NOTICE OF DECISION

Preliminary plat of “Desert Sky” subdividing 38.2 acres into 221 residential lots, 8 commercial lots and 5 tracts.

File No. S-2023-101

**DECISION APPROVING
“DESERT SKY” PRELIMINARY
PLAT APPLICATION**

Desert Sky Preliminary Plat

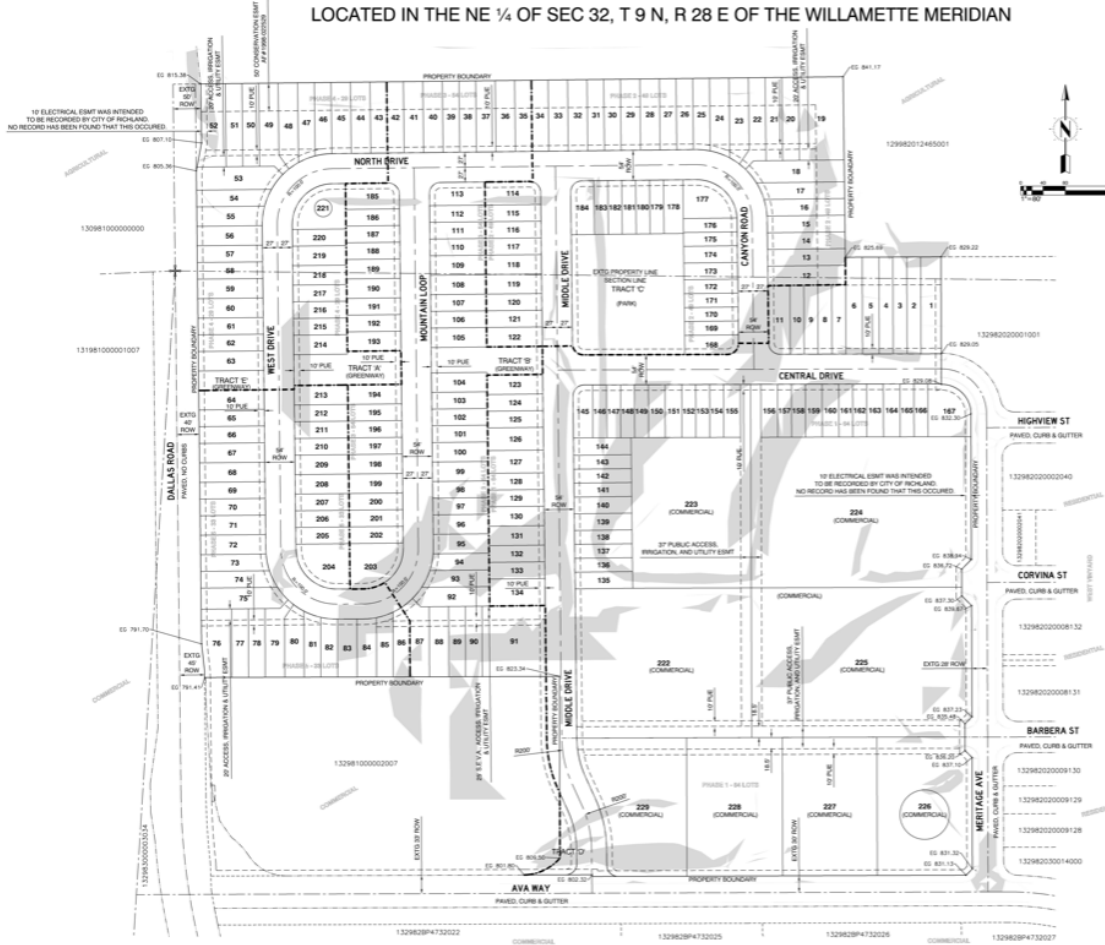
15 9. *Revised Preliminary Plat Design*, submitted by Applicant during the public hearing
16 to address comments from Public Works staff, mostly dealing with turning radius for
17 internal street system, and Tract E ‘greenway’ access to Dallas Road corridor.

- 23. The road section proposed on sheet “PP200” indicates a rolled curb. This curb style is not city standard and is not acceptable. The city has a 26-foot wide narrow street standard with offset sidewalk that shall be constructed. Because of the high driveway density typical of this type of development, the applicant shall provide adequate off-street parking to accommodate the loss of on-street parking.

- 24. The proposed grade of “North Drive” at the intersection with “Middle Drive” is over 5% (sheet “PP107”). At these grades the ADA pedestrian ramps will not be able to meet current design standards. The slope of this intersection needs to be adjusted to comply with current ADA standards. The proposed grades may also create an intersection sight-distance problem.

- A. **Plat Design, Phasing.** Development of the plat shall be substantially consistent with drawings provided in the Preliminary Plat maps included as part of the applicant's revised plat design materials (*Ex. 9*), subject to modifications necessary to comply with these conditions of approval. The Preliminary Plat may be developed in 5 (five) phases, as identified in the application materials and depicted on the revised plat plan sheets included as part of *Ex. 9*.
